ADDENDUM NO. 1
Amelia River Waterfront Stabilization Parking Lots C & D
City of Fernandina Beach
Invitation to Bid # 21-06
Issued: May 25, 2021

III. Changes to Drawings: (See attached)

Amelia River Waterfront
 Stabilization
 Parking Lots C & D
 Town/City: Fernandina Beach
 County: Nassau State: Florida

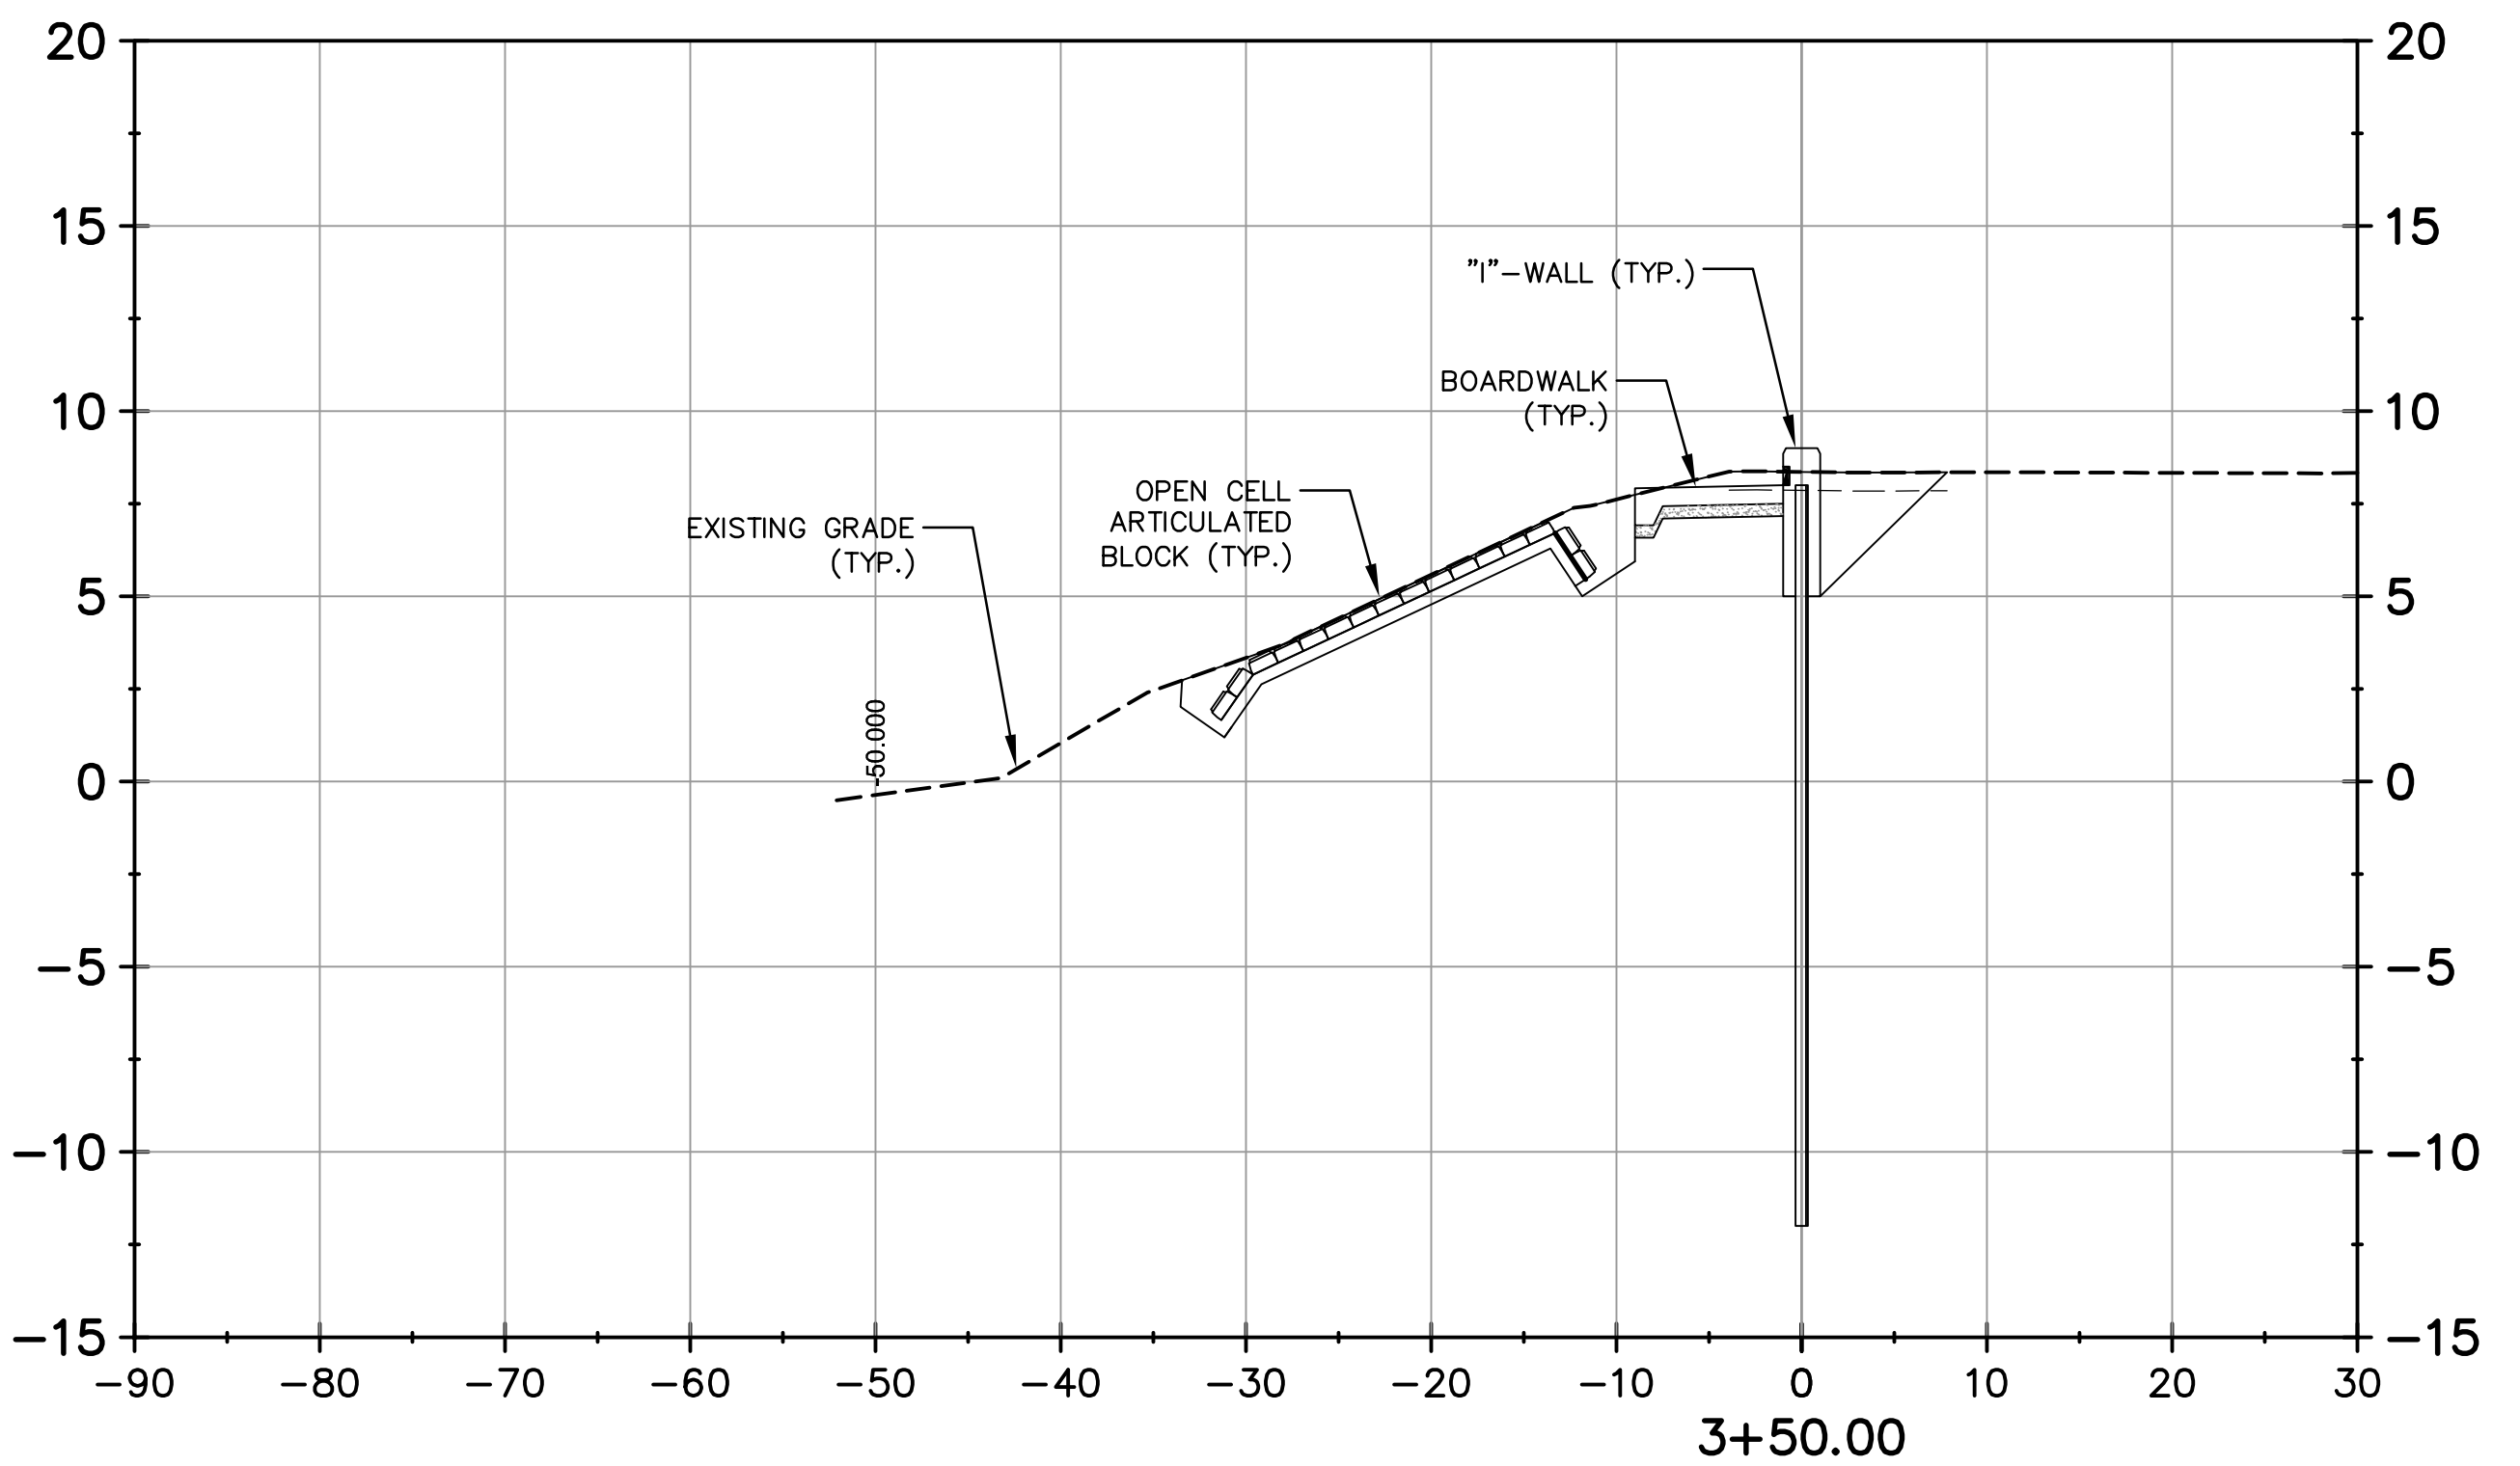
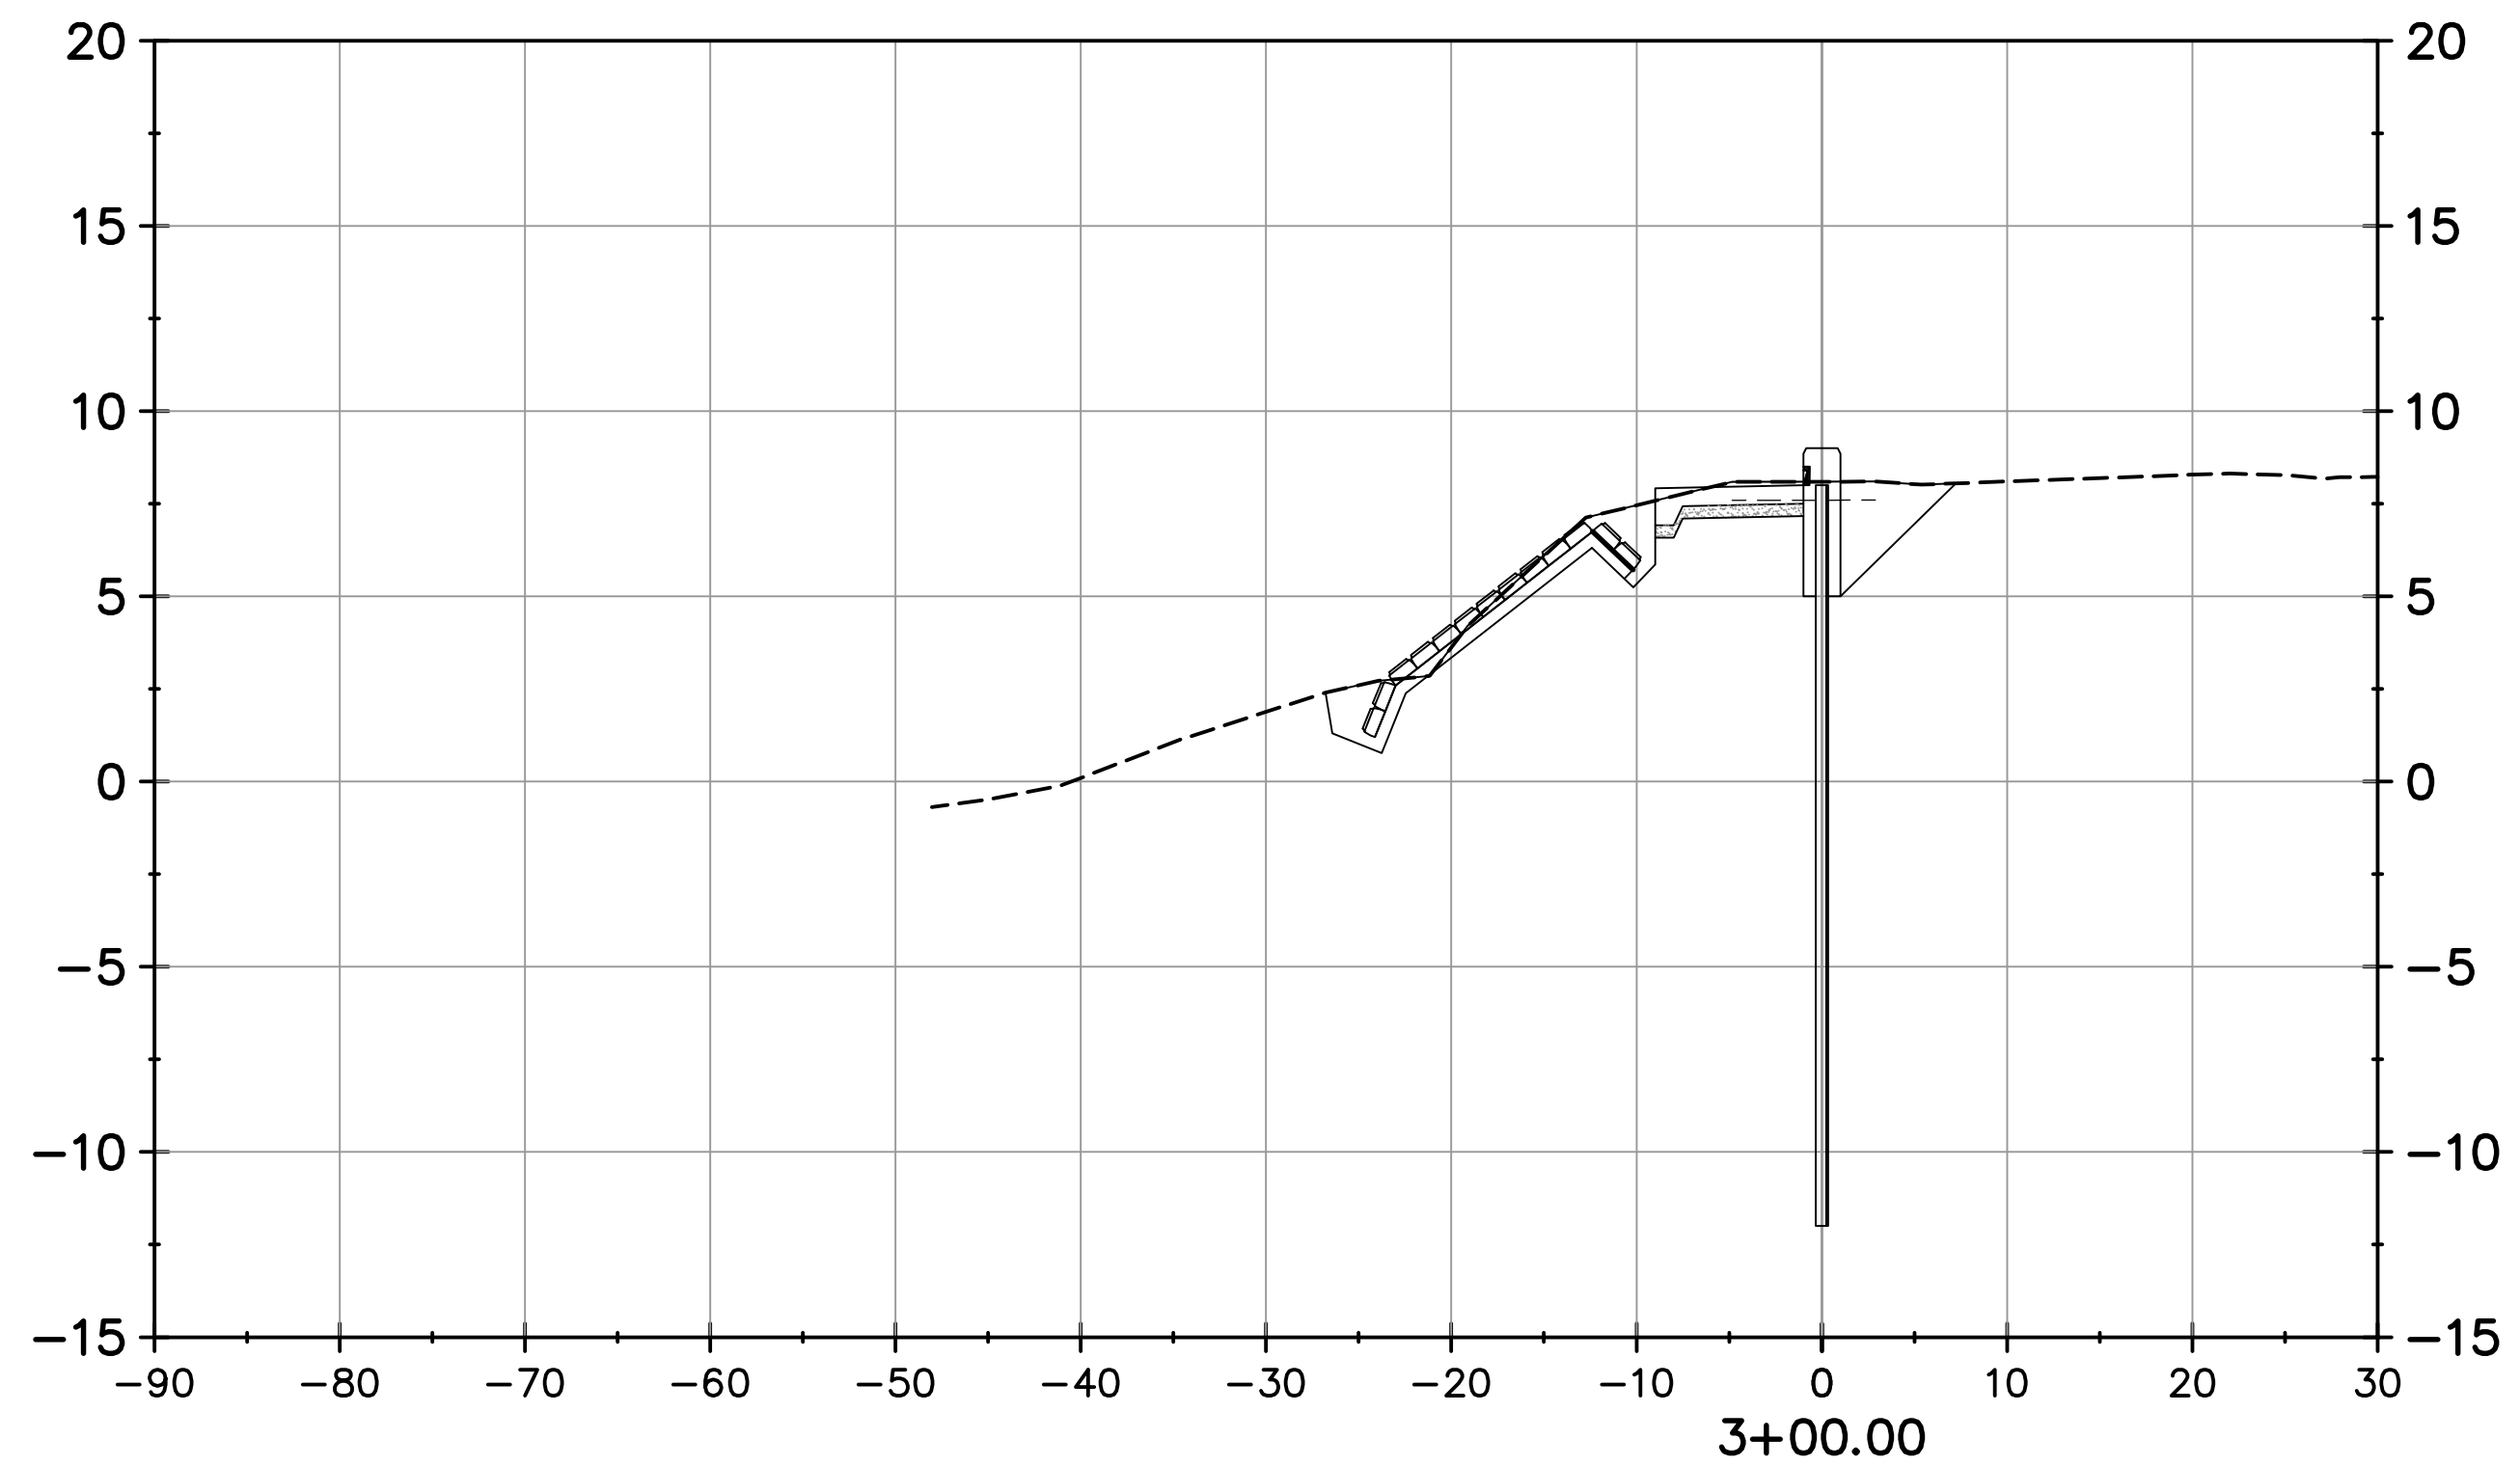
- 20) Sheet C6-1 - Revised I-Wall & Boardwalk Alignment and Cross Sections Adjusted.
- 21) Sheet C6-2 - Revised I-Wall & Boardwalk Alignment and Cross Sections Adjusted.
